SSD_10393
LH (CIS)

Application No: SSD_10393
Proposal: Development of a new sports and science building
Property: 128 Miller Street, North Sydney – Monte Sant Angelo Mercy College

Re: SSD- 128 Miller St, North Sydney- Monte Sant' Angelo

PROPERTY	128 Miller Street, North Sydney
PROPOSAL	Alterations and additions to a school (State Significant Development)
DATE	10/3/2020
TIME	<i>Commenced:</i> 3.45pm <i>Concluded:</i> 4.30pm
HELD	Supper Room, North Sydney Council Chambers

Plan showing the square alignment of the heritage buildings around the Holy Lawn except for the Chapel.

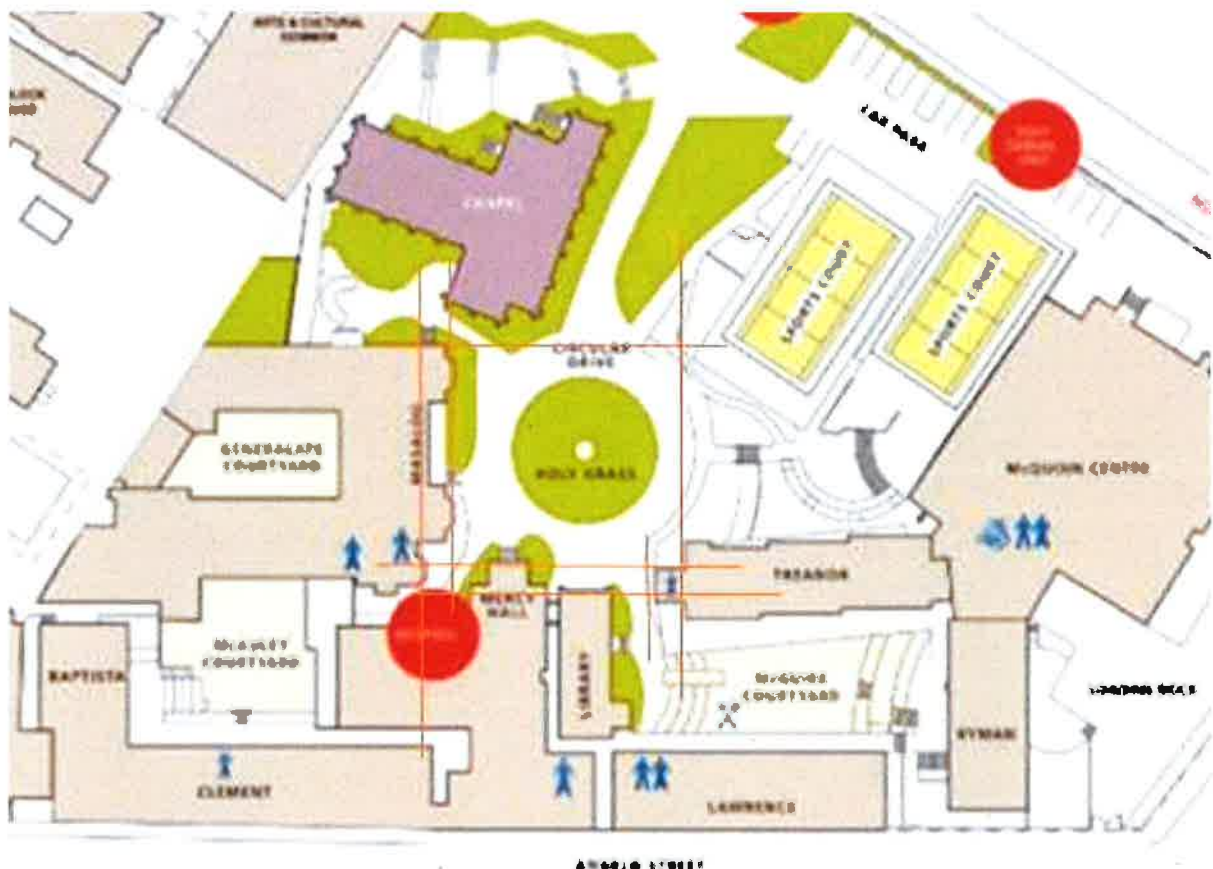
- **Curtilage and Setting** – The visual curtilage and setting of the heritage significant buildings should be retained. The facades of Mercy Hall, the Library, Masalou and Treanor are all aligned either perpendicular or parallel to each other (see image below) and assist in creating a spatial relationship with each other in a square formation as well as creating a sense of enclosure to the Holy Grass. The Chapel as noted above, has a traditional east/west alignment, opening up to the driveway and gate. The McQuoin Centre on the corner of Berry/Miller Streets is set far enough downslope and away from the Holy Grass and the heritage-significant buildings that it reads as a separate built element on the site and has little relationship with them.

The proposed development, however, relates to none of the historic existing alignments and established curtilage but instead relates to the alignment of the McQuoin Centre and the Miller Street frontage. The new development should acknowledge the alignment of the heritage buildings as it will be seen in the context of the historic buildings due to their proximity.

Because of the proposal's bold design and monolithic massing, it is likely that it will visually overwhelm the traditional setting of the group of heritage significant buildings and their visual curtilage over the Holy Grass. Although the northwest corner has been 'eroded' at Ground Level on the North Elevation of the design, the curved frame on the North Elevation takes the eye to the right angled corner of the building on the upper levels giving it visual dominance. The new development will therefore confuse the setting of the heritage items by its corner conflicting with the established building alignments.

It is therefore recommended that to comply with Part B Section 13.4 Objective O1, Provisions P1 and P3, that the façade on the north elevation be parallel to the Chapel or that it turn approximately halfway along its North Elevation to be parallel with the Chapel. This will acknowledge the alignment of the Chapel and the established building alignments at the cultural core of the site rather than creating an incursion. It will also allow the formality of the driveway to the highly significant Holy Grass to be retained and potentially enhanced.
